Model: Stinger – C1		Date: 31-Aug-99	No.: RA250001
Subject: Exit plate guide location		Prepared by: K. Miura	
From: Technical Service Dept., GTS Division			
Classification:	<input checked="" type="checkbox"/> Troubleshooting <input type="checkbox"/> Mechanical <input checked="" type="checkbox"/> Paper path <input type="checkbox"/> Other ()	<input type="checkbox"/> Part information <input type="checkbox"/> Electrical <input type="checkbox"/> Transmit/receive	<input type="checkbox"/> Action required <input type="checkbox"/> Service manual revision <input type="checkbox"/> Retrofit information

Model: Stinger-C1		Date: 15-Oct-99	No.: RA250003
Subject: Service Manual Correction		Prepared by: Kenta Miura	
From: Technical Service Dept., GTS Division			
Classification:	<input type="checkbox"/> Troubleshooting	<input type="checkbox"/> Part information	<input type="checkbox"/> Action required
	<input type="checkbox"/> Mechanical	<input type="checkbox"/> Electrical	<input checked="" type="checkbox"/> Service manual revision
	<input type="checkbox"/> Paper path	<input type="checkbox"/> Transmit/receive	<input type="checkbox"/> Retrofit information
	<input type="checkbox"/> Other ()

Model: St

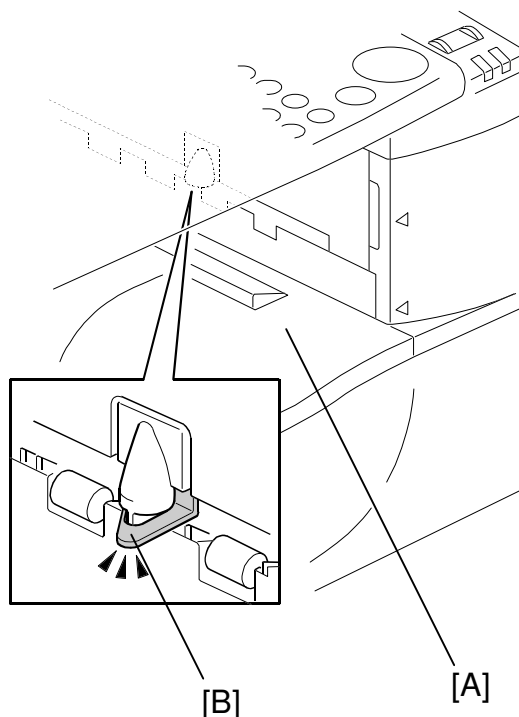
Paper misfeed at the exit guide plate.

The exit cover [A] was reinstalled without first pushing up on the exit guide plate [B], causing the exit guide plate to become caught between the cover and copier. This caused the paper to misfeed when it was fed out.

When reinstalling the exit cover, hold up the exit guide plate so that it will remain positioned above the cover.

Page: 4--55

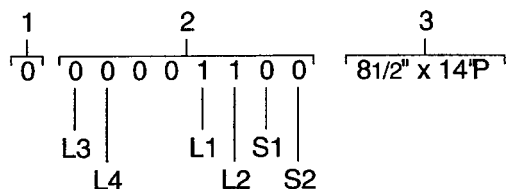
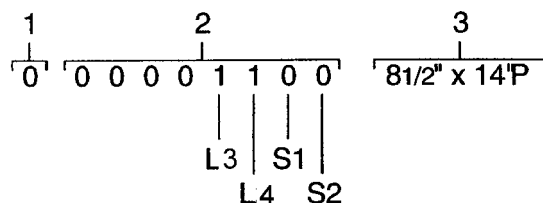
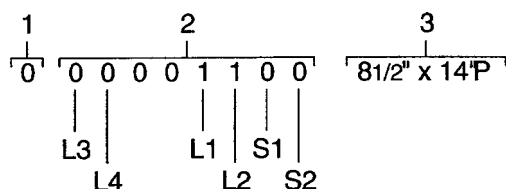
OLD

NEW

A4/A3 version machines

LT/DLT version machines

NOTE: The length sensors L1 and L2 are used only for A4/A3 version machines.

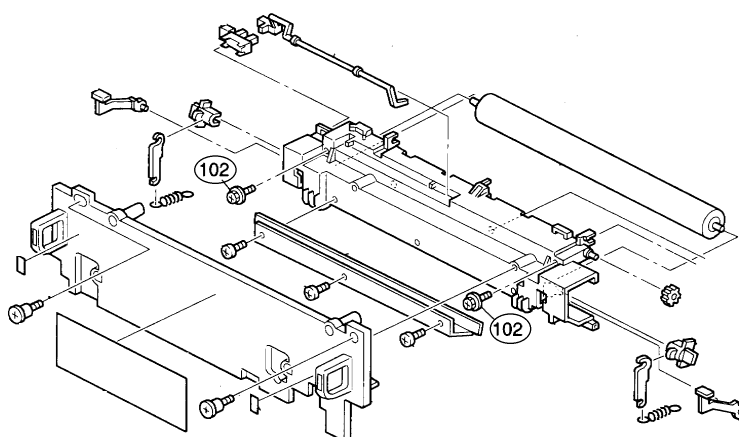
The screw holes are stripped after rebuilding the fusing unit.

Plastic fusing unit base.

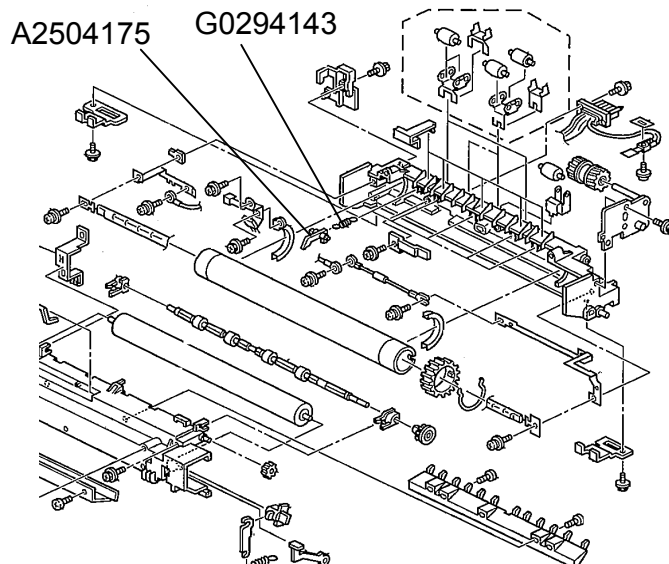
Insufficient tension of the pawl spring (G0294143).

The spring tension was increased, and the spring P/N was changed from G0294143 -> A2504143.

If any occurrences are reported from the field, please replace the old spring with the new A2504143 spring. However if the tip of the pawl (A2504175) appears to have deformed, please replace the pawl itself along with the spring. For information on the cut-in serial numbers for this modification, refer to MB MA250020.

Illustration A

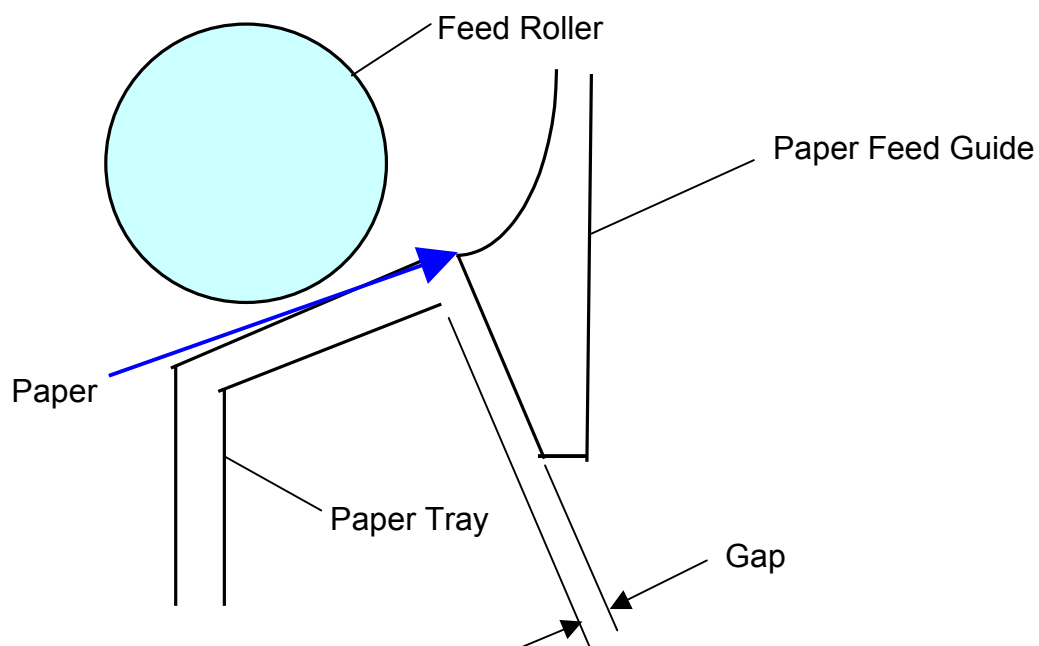
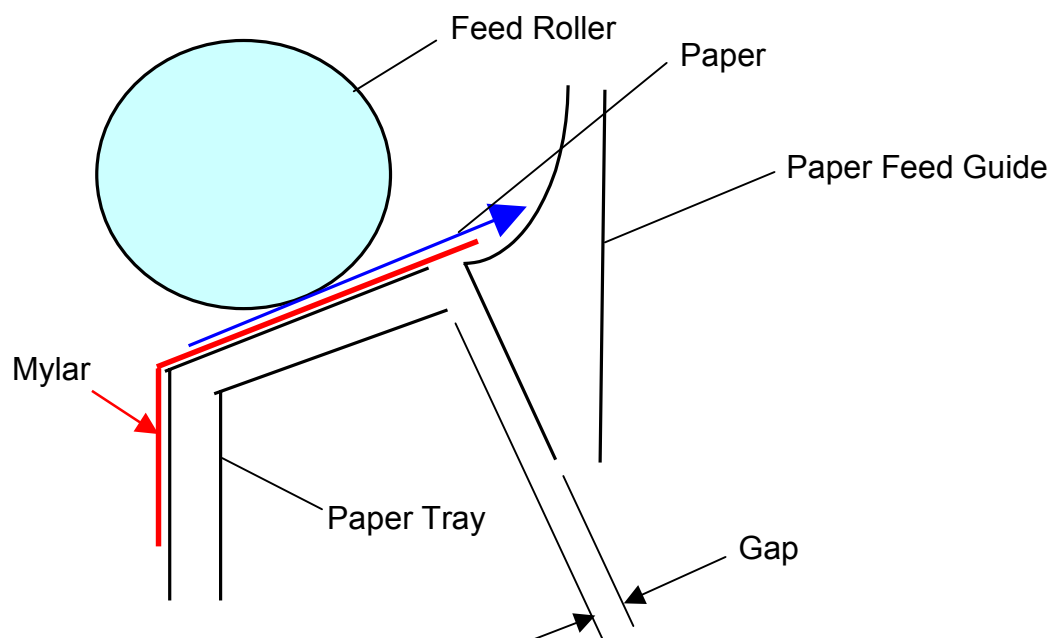
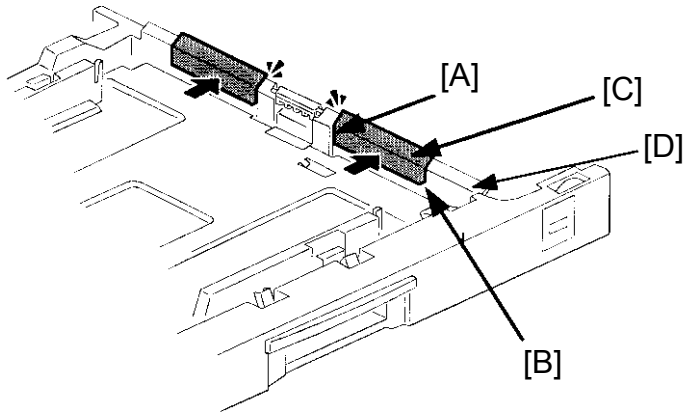
A strip of mylar (A2502831) is added to the paper feed tray, as shown in illustration C. This will ensure that the leading edge will not run into the guide and the paper will be properly fed, even if the paper is curled to begin with. See illustration B.

b. G8004854/G0294181 rollers:

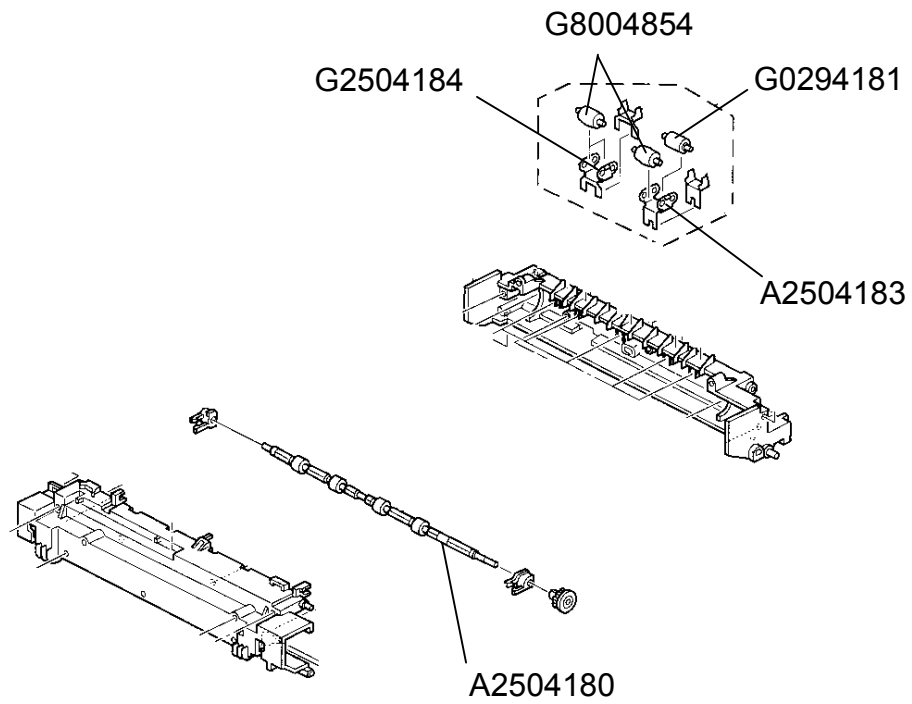
When the user tries to remove the jammed paper without first releasing the pressure release lever, this can put excessive stress on the spring plate causing it to deform. This can also put excessive stress on the roller shaft, causing shaft damage and noise.

Replace the rollers that exhibit the noise, along with their spring plates (A2504183/ A2504184, respectively). Although the noise may subside temporarily with the Barierta grease mentioned above (A2579300), the cause for this noise is not friction, but physical damage. Therefore, the noise would most likely reoccur without roller/plate replacement.

However if the replacement parts were not available and the grease was needed as a temporary solution, it is critical to use grease A2579300 only. As stated above, any other grease will cause a gradual buildup of friction and cause a recurrence of the noise.

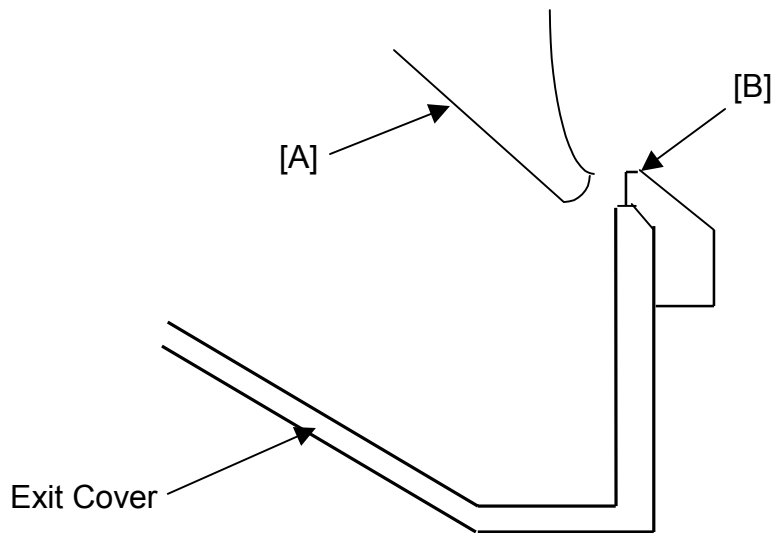
An accordion jam occurs near the paper exit area when the 1-bin sorter is installed. This occurs most often with the first 2 pages when outputting to a non-default tray, as the junction gate is activated (see below).

The junction gate [A] of the 1-bin sorter contacts the exit cover ribs [B], causing the gate not to function properly, which leads to the jam.

By moving the junction gate back and forth manually, check to see if the gate can move free of the exit cover ribs. If it cannot, replace exit cover A2501324 (Europe) or A2501274 (other) with the modified cover (A2501327), which has been designed to prevent any interference between the ribs and gate.

It was announced in MB MA250031 that the old exit covers mentioned above should be replaced with A2501325 (Europe) and A2501281 (other). However, to further ensure that the symptom would not occur, the new covers were modified again to A2501327 (see above), which is common to all Stinger-C mainframes.

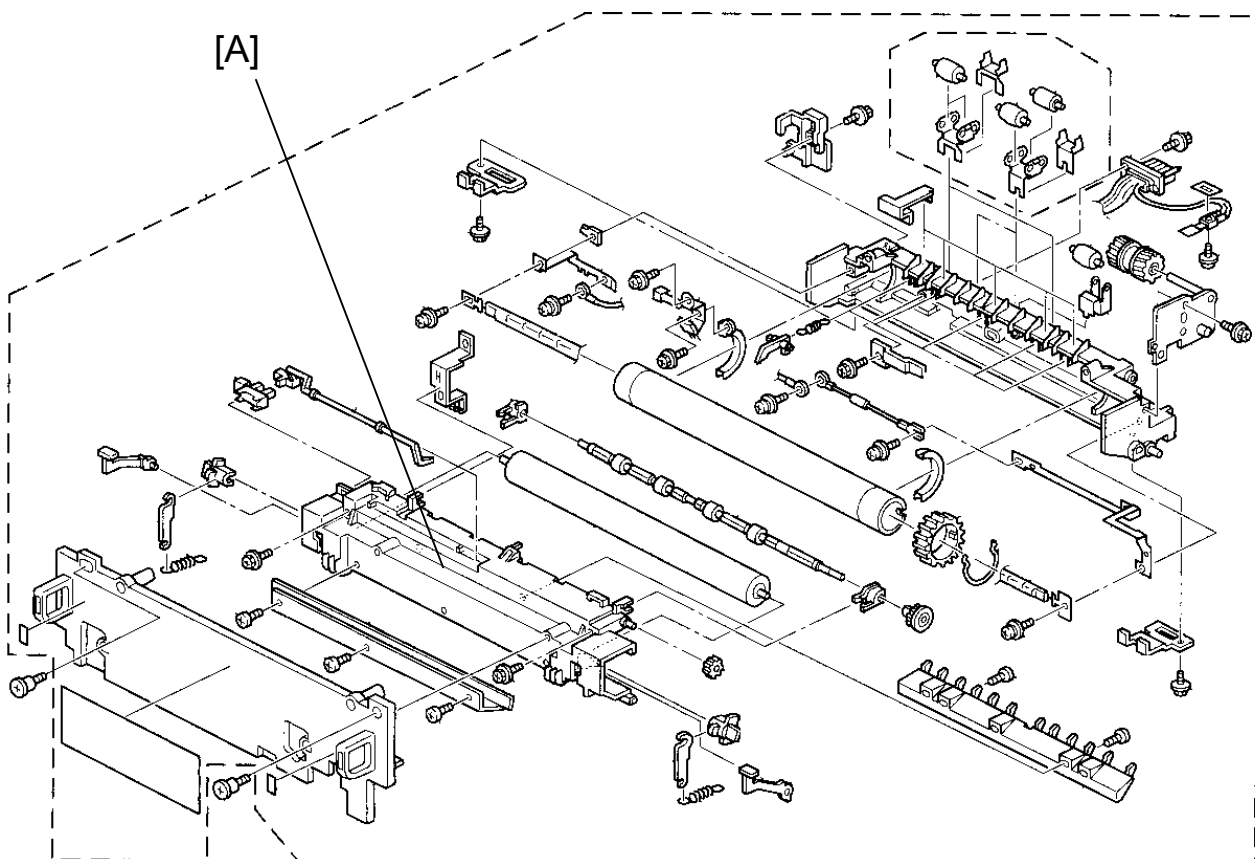
Accordion jams occur near the paper exit area, especially when the type of paper used curls easily or has already been printed on one side (re-used).

To ensure that the leading edge of the paper is properly fed between the exit rollers, a rib has been added to the pressure roller case [A] that will act as a guide. The P/N was changed from A2504105 to A2504106. Please refer to MA250033 for the cut-in serial numbers.

In addition, when installing the new A2504106 pressure roller case in machines that contain the old G0294106 case, it is necessary to replace other components at the same time. Please see MA250003 for a description of these parts and the cut-in serial numbers.

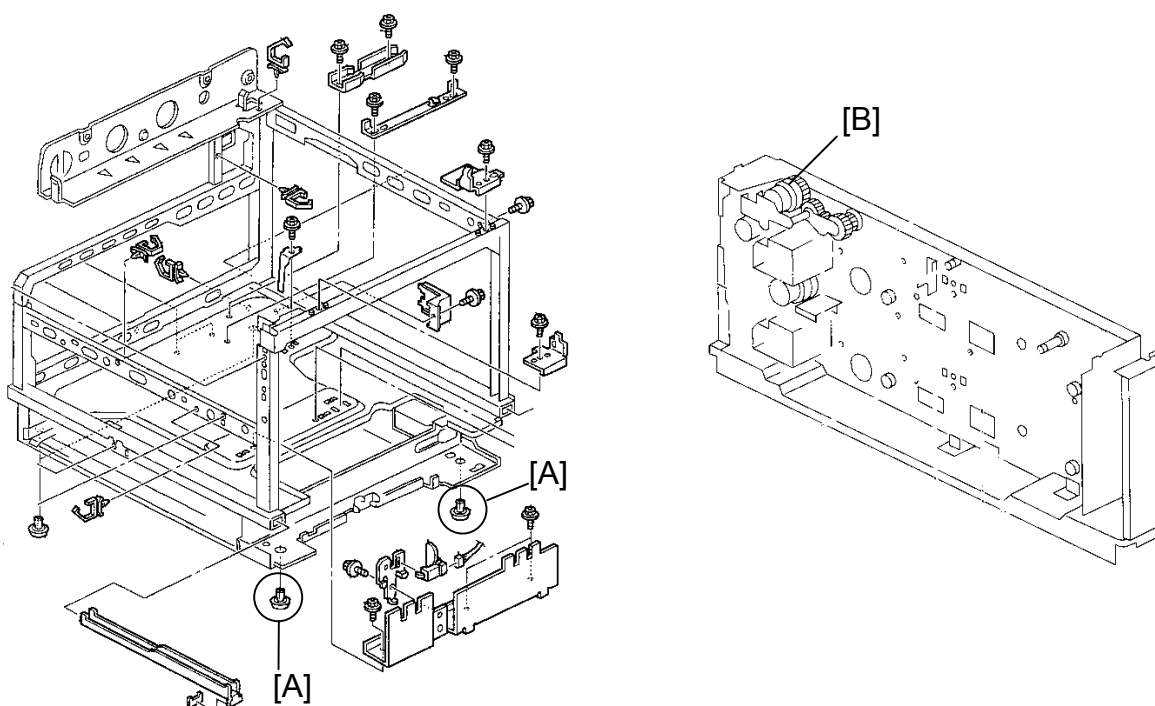
Noise from the area where the mainframe connects to the paper feed unit.

One or more of the legs [A] attached between the mainframe and paper feed unit come off, decreasing the gap between the two. Since the upper plate of the PFU has a raised area to accommodate the uppermost paper feed clutch [B], the mainframe can sometimes contact this raised portion when the gap is decreased enough. The noise of the clutch is then transmitted through and amplified by the mainframe bottom plate.

If the noise occurs, check if any of the legs have detached and replace any that have.

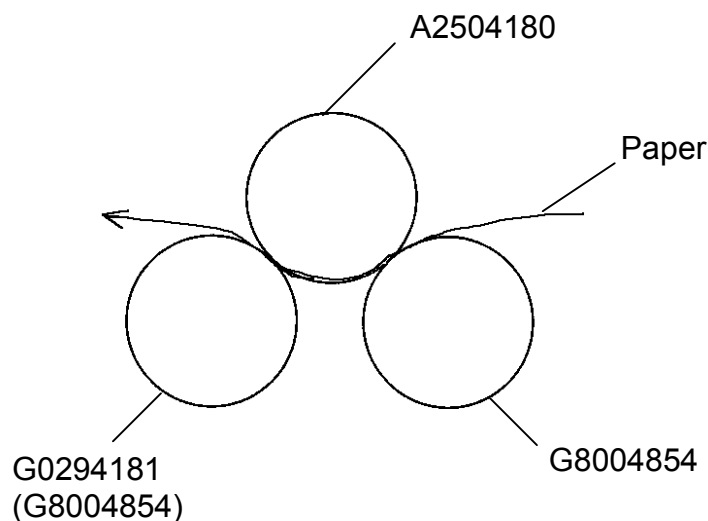
Paper curling

One factor that determines the degree of paper curl is how well the group of 3 exit rollers are in contact with each other. If the 3 types of rollers are not tightly in contact with one another, the de-curling function does not operate correctly. Please see the two illustrations below.

Check the spring plate to see if it is bent and the exit rollers to see if they are tightly in position as they should be. If this is difficult to determine from a visual inspection, the surest way to fix this is to replace the fusing unit with a new one (or one that is known to have no problems).
